# Sutherland to Cronulla Active Transport Link Stage 2

## Submissions Report

Transport for NSW | June 2022

**Figure 3-3: Section for further investigation in Miranda**

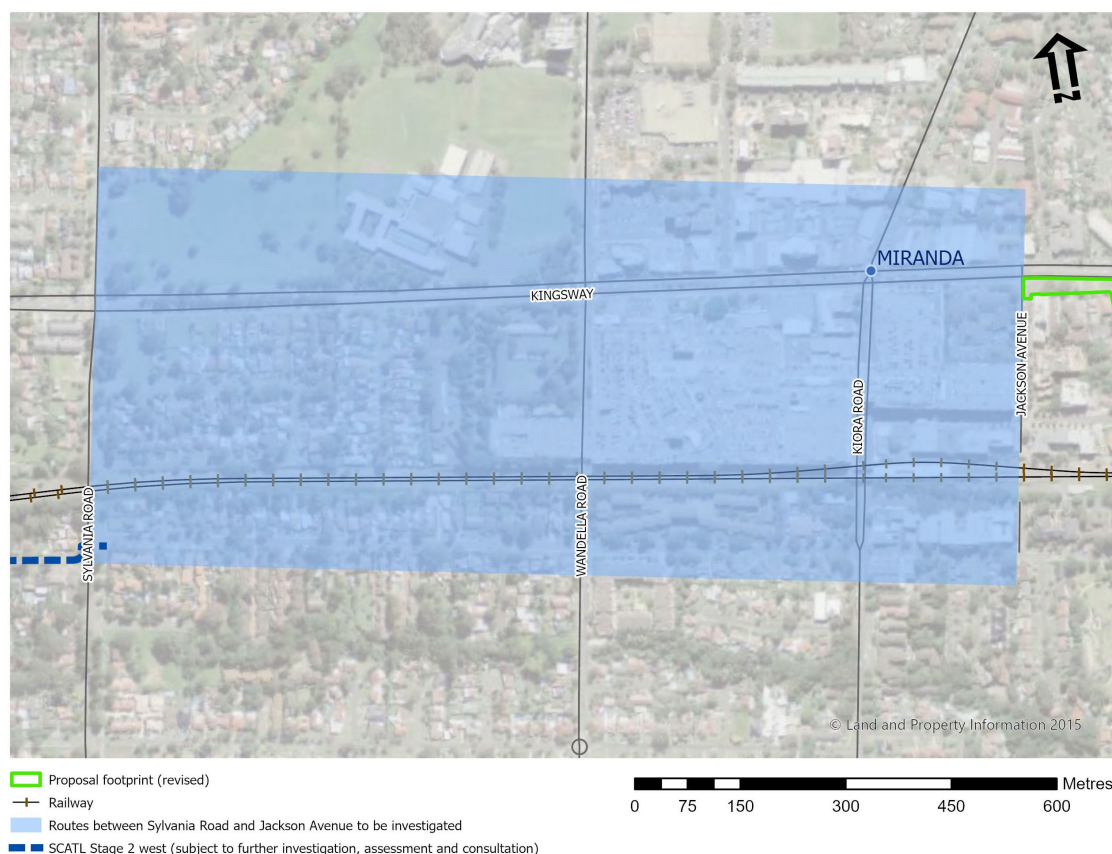
Transport has considered community feedback and has decided to further investigate route options between Sylvania Road and Jackson Avenue.

Transport will develop route options for this section and carry out consultation with Council, residents and businesses. An addendum to the REF (to be publicly displayed for community and stakeholder comment) will be prepared before proceeding with a new route through this part of Miranda.

**Figure 3-4: Proposed changes to SCATL route along southern side of the Kingsway**

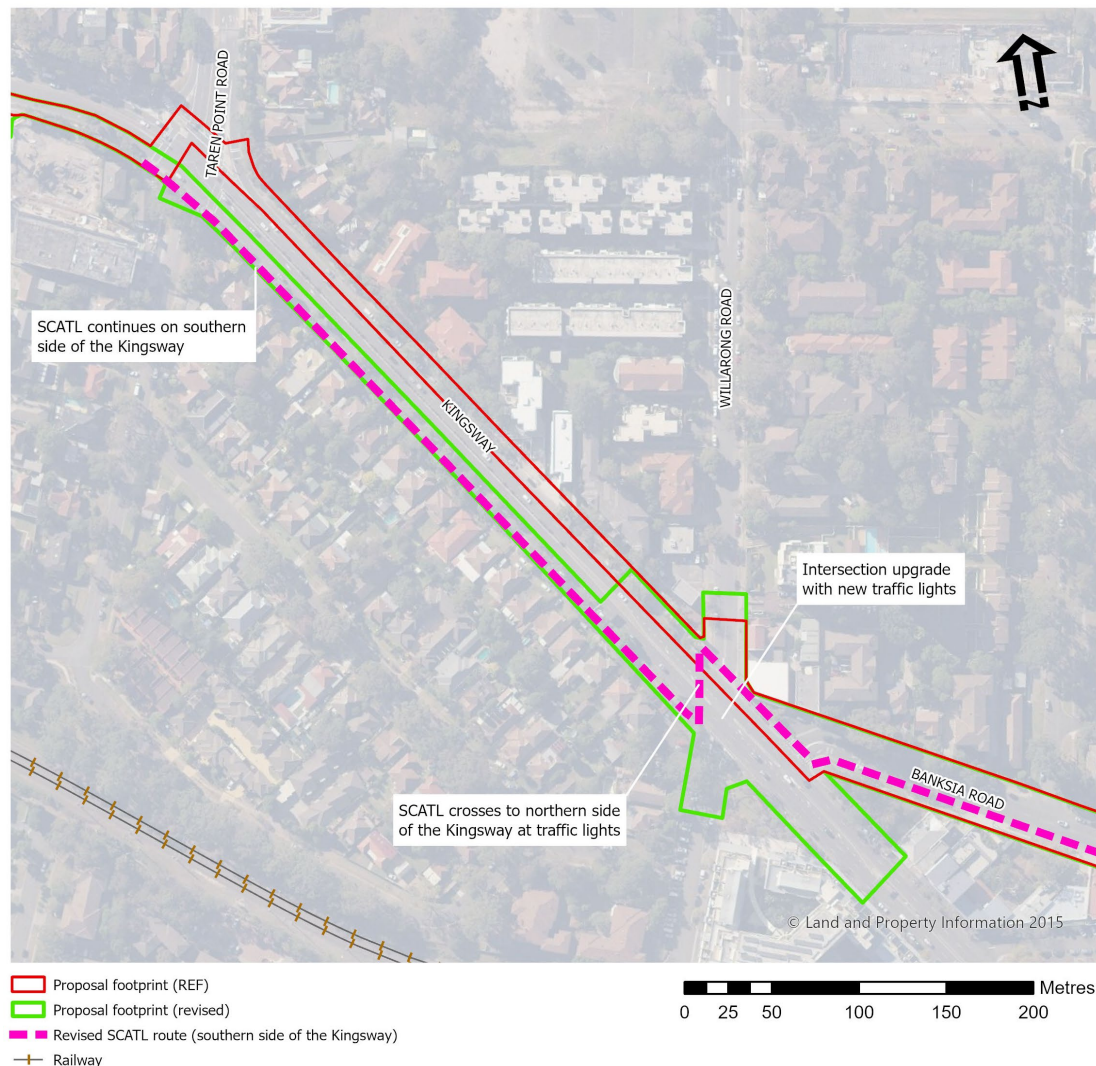
Transport has considered Council and community feedback and has decided to make changes to the proposal along the Kingsway between Taren Point Road and Banksia Road and at the Willarong Road intersection (see Figure 3-4).). The proposed changes would help ensure a safer, more efficient flow of local traffic, pedestrians and active transport users.

The proposed changes include the following:

- Revised SCATL route between Taren Point Road and Banksia Road.
- Upgrading the intersection of Willarong Road and the Kingsway with traffic lights
- New pedestrian / bicycle crossings on all legs of the intersection
- closure of the right turning entry into Banksia Road from the Kingsway
- Changed parking conditions on Willarong Road.

**Figure 3-5: Proposal footprint adjustments – Jackson Avenue, Gurrier Avenue, Higherdale Avenue and Miranda Road**

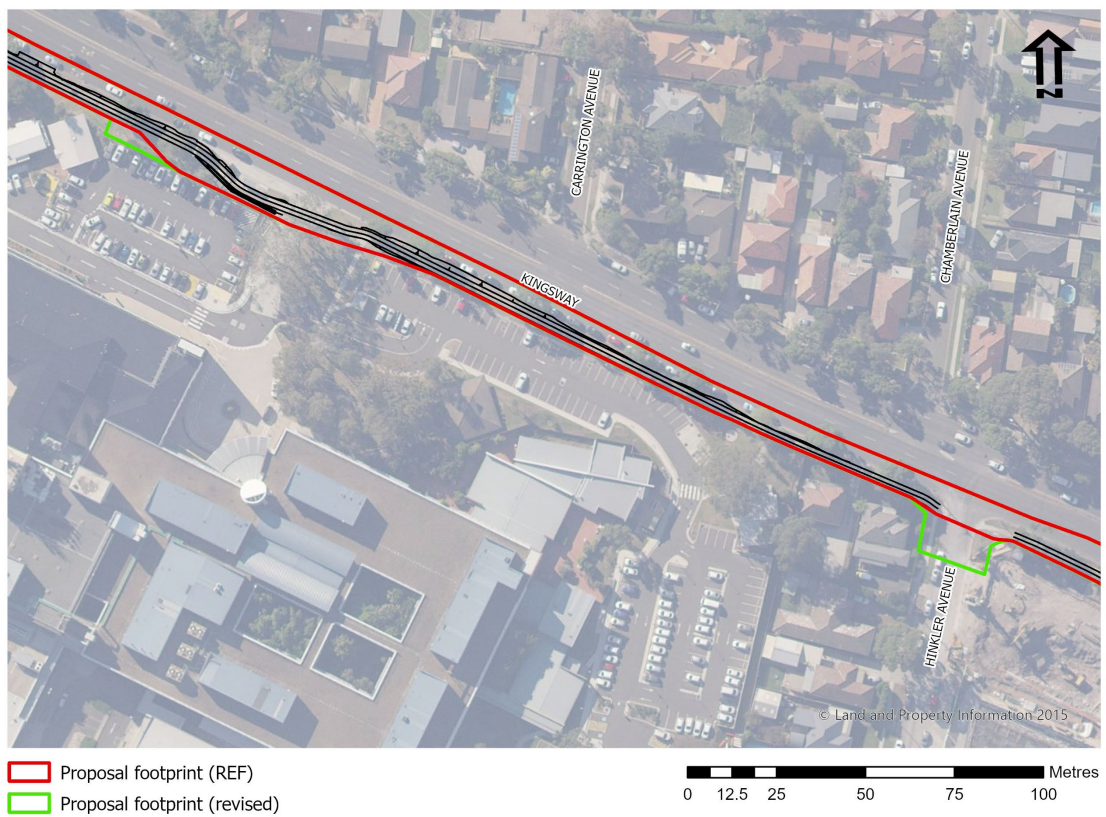
- Jackson Avenue – boundary extended further to the south to accommodate drainage works (refer to Figure 3-5)
- Gurrier Avenue – boundary extended further to the south to accommodate pavement restoration of the existing raised threshold crossing (refer to Figure 3-5)
- Higherdale Avenue – boundary extended further to the south to accommodate pavement works associated with new raised threshold crossing (refer to Figure 3-5)
- Miranda Road – minor adjustment to allow kerb ramp construction (refer to Figure 3-5)

**Figure 3-6: Proposal footprint adjustment – Carramar Crescent**

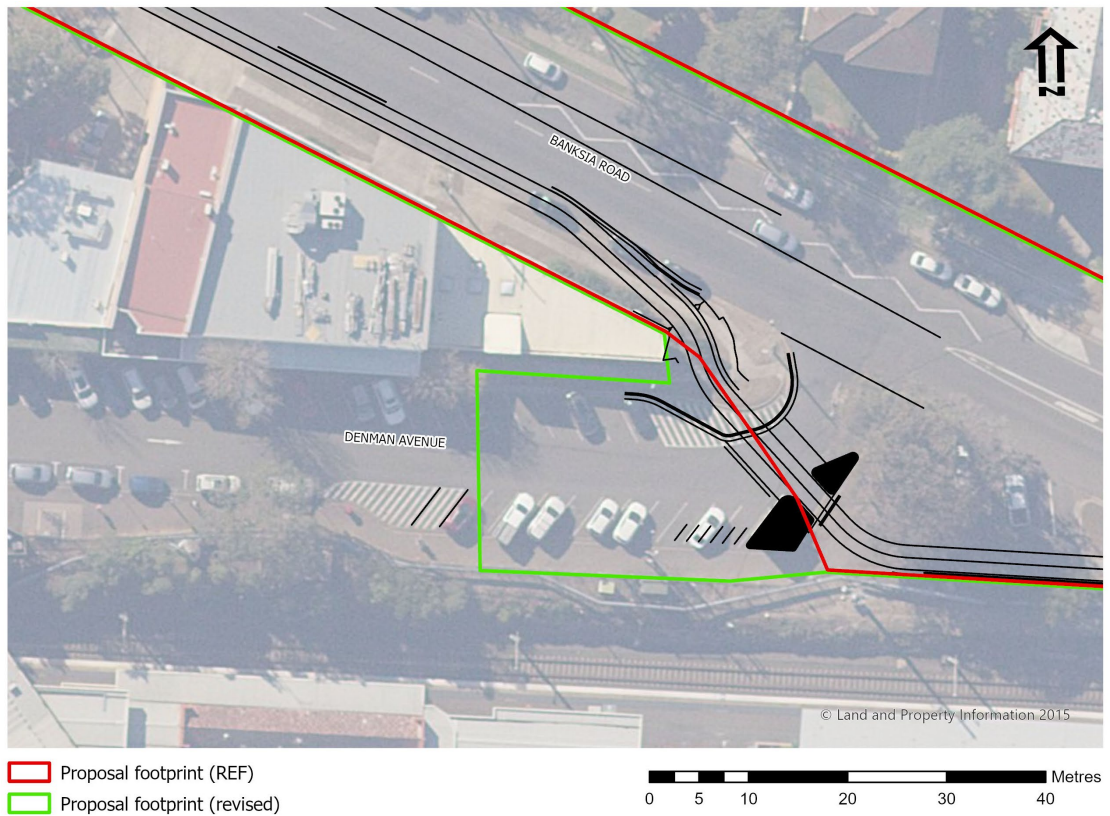
- Carramar Crescent – minor adjustment to adequately accommodate crossing (refer to Figure 3-6)
- Kingsway (on Sutherland Hospital boundary) – Area of proposed construction lease (to facilitate access) (refer to Figure 3-7)
- Hinkler Avenue – boundary extended further to the south to accommodate power pole / streetlight adjustments (refer to Figure 3-7)
- Denman Avenue / Banksia Road intersection – boundary extended further to the west along Denman Avenue to accommodate the proposed new raised threshold crossing and parking adjustments (refer to Figure 3-8)
- Denman Avenue – minor adjustments to accommodate refinement of the path alignment
- Denman Avenue / Gannons Road intersection – boundary extended further to the east to accommodate adjustments to pedestrian crossings (refer to Figure 3-9).
